07.3–151 Converting leak line for pressure damper

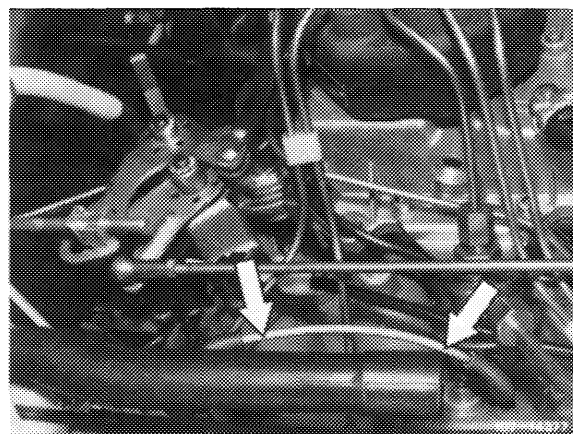
Starting approx. October 1977, the leak line for the pressure damper is connected to the contoured hose for engine breathing.

On previously manufactured vehicles, the contoured hose for engine breathing on cylinder head cover should also be replaced when renewing the pressure damper. Connect leak line to contoured hose and make shorter. Close connection for leak line used up to now with rubber cap part no. 000 987 11 45. When renewing contoured hose, also connect leak line of pressure damper to new hose.
